Note / Memo

To: Barratt David Wilson
From: Thomas Green, Keming Hu
Date: 12 September 2024
Copy: [Click to enter "CopyTo"](#)
Our reference: PC6658-RHD-XX-XX-ME-X-0001-P03
Classification: Project related
Checked by: Final

Subject: East Wittering - Independent Review

Figure 3-1: Location of sea defences and CCO profiles

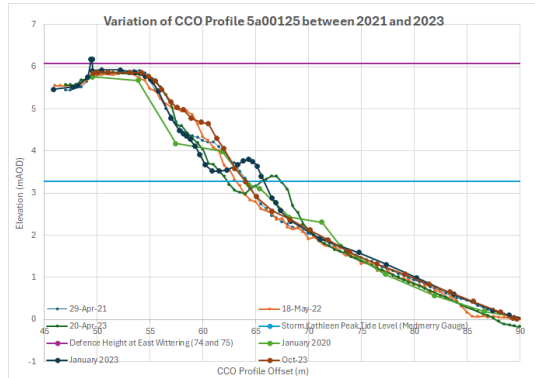
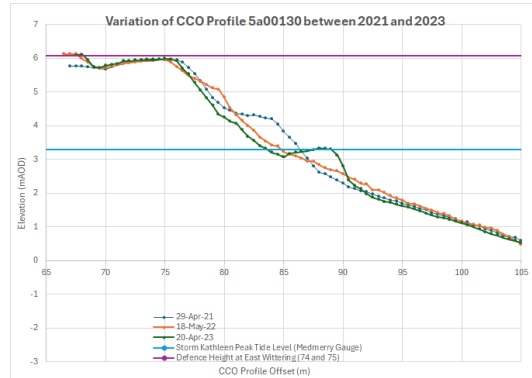
HRW used the most up-to-date beach profile data as recommended in the EA's Coastal Modelling Standards Update. Analysis included beach profiles surveyed by the Channel Coastal Observatory (CCO) along the 1,100m length of coastline making up shingle defences 74 and 75 as shown in **Figure 3-1** below obtained during the period of 2021-2023. There are 25nr CCO profiles covering these two shorelines. CCO profile 5a00121 is located at Bracklesham Road to the east of defence 74. Profile 5a00145 is located at Shore Road to the west of defence 75. A selection of the CCO profiles taken from the Southeast Regional Monitoring Programme is shown in **Figure 3-2** which includes profile 5a00146 for comparison which is located on shingle beach 76.

HRW opted to use a variety of crest levels as a health check including 5.4m ODN, 5.7m ODN and 6.07m ODN in their overtopping assessment. From the surveyed beach profiles, HRW obtained an average slope of cot = 7 between 0m ODN and the beach crest, which was used in the wave runup and overtopping calculation.

From the surveyed beach profiles in the period of 2021-2023, RHDHV agrees that the use of 3 crest levels (namely 5.4m ODN, 5.7m ODN and 6.07m ODN) and beach slope of cot = 7 is reasonable.

Figure 3-2: CCO beach profiles at sea defences 74 and 75

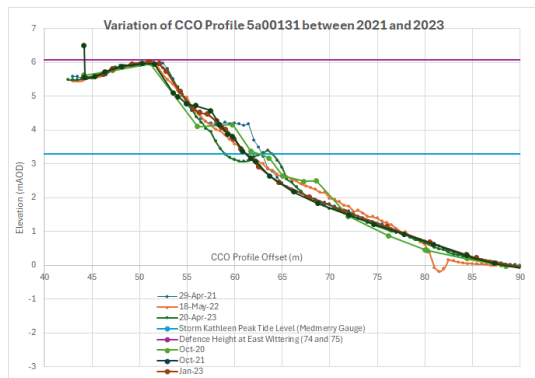
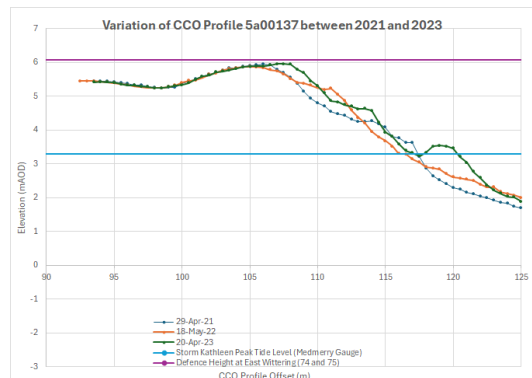
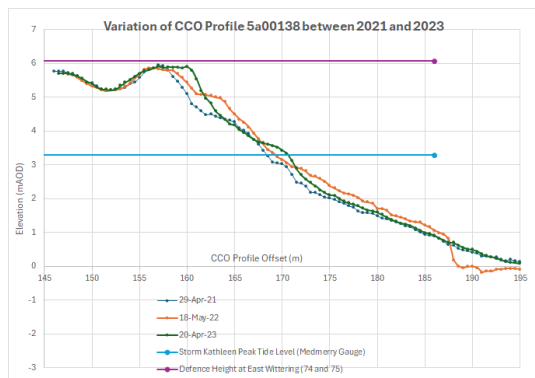
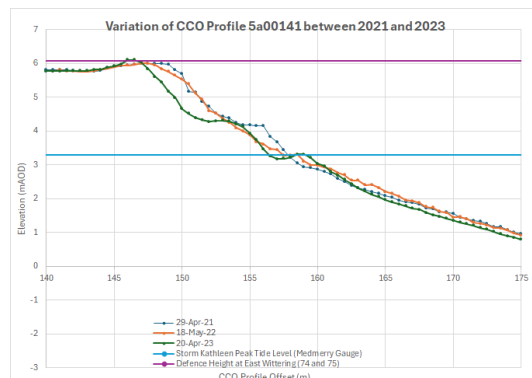
The profiles show crest levels varying between 5.4m ODN and 6.09m ODN. However, where the profile shows a crest level of 5.4m it does not account for the higher natural ground levels behind the beach which East Wittering is built on as shown in **Figure 7-2**. It should be noted that the use of 5:1 scale along the x and y axes exaggerates the crest level variation along the CCO profiles.

It should be noted that JBA used 6.07m ODN as their crest level for shingle defences 74 and 75 in their updated modelling for the 2023 SFRA.

Figure 7-2: shingle beach at sea defence 75 with 74 in the background

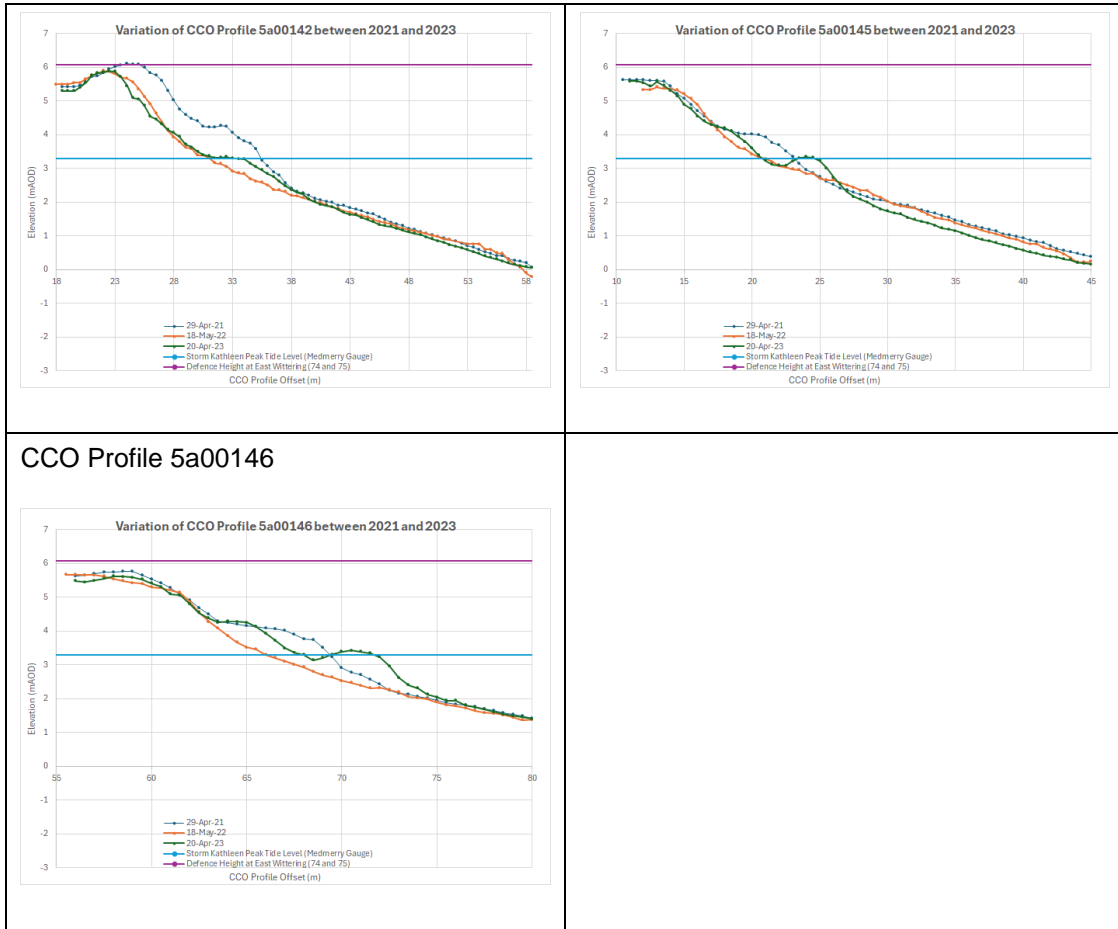
Floodline Consulting Limited provided photographic evidence that the shingle beach at defences 74 and 75 is backed by higher ground with a slightly upwards slope (see **Figure 7-2**). RHDHV does not believe this can be described realistically by any form of “crest width” and the effect quantified accurately by Equation 6.8 of EurOtop. However, it indicates that it is conservative to use the boundary between shingle slope and high ground as the output location, as suggested by the Zero width crest. The overtopping rates are certain to be lower further landward on the higher ground.

A EurOtop defence crest with a value of Zero metres in the Council’s SFRA is not realistic given that there are no wave walls in this location and a value of Zero metres is not realistic or sustainable just from the considerations of ground slope stability. It is also likely that during a significant wave overtopping event, shingle would be carried over any low defences in this location, further rendering a Zero crest width as unrealistic.

Figure 7-1: maximum overtopping vs crest width

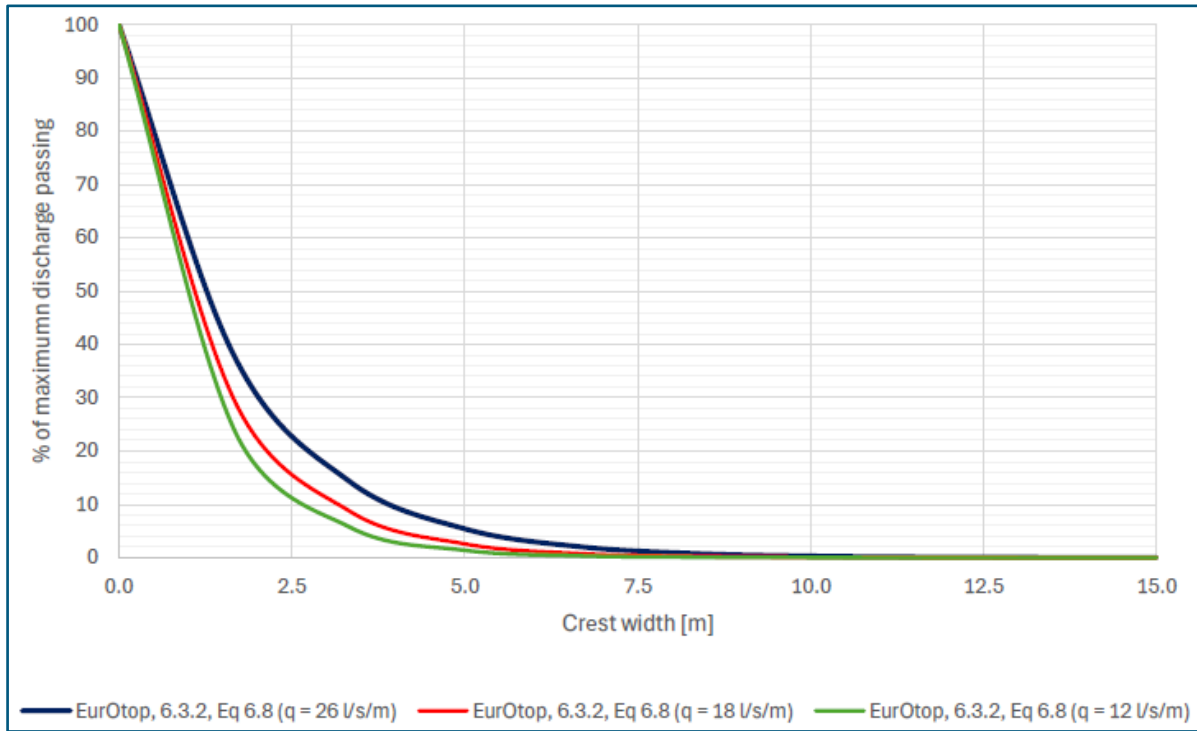
HRW provided a separate note which discussed the effect of flood defence crest width on wave overtopping using Equation 6.8 of EurOtop. The equation was developed from limited cases of highly permeable rock structures with large interstitial voids and high porosity. It gives an exponential reduction of overtopping as a function of crest width, shown in the decay curve shown in **Figure 7-1** provided by HRW.

The HRW Report has made use of the Council SFRA EurOtop schematisation for comparative purposes and Equation 6.8 does apply to EurOtop defence schematisations. Consequently, whilst not realistic for shingle beaches, it is reasonable in this case, to make use of this equation for comparative purposes.
